Studio 2H Design, LLC
Alabama A&M University
Fine Arts Building Interior Finishes Upgrades
S2HD Project No. 202002

ADDENDUM NO.2
March 26, 2020

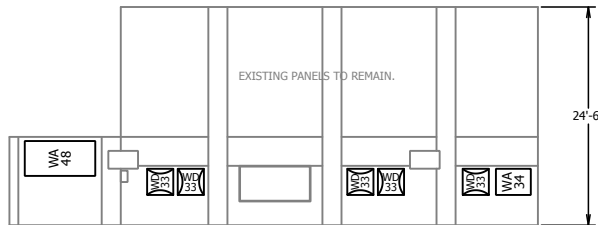
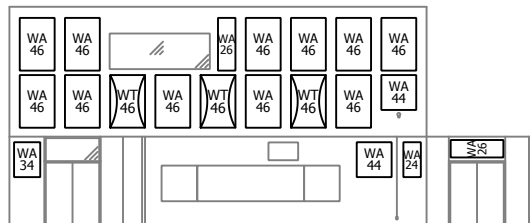
a. Response: All door frames this area are to be painted to match the existing door frames color.
12. Add acoustical wall panels on the other two CMU wall at Band Room 138.

a. Response: Omit Elevations 3 & 4 titled ALTERNATE NO.3 in their entirety and replace with Wenger drawing 19P32458.
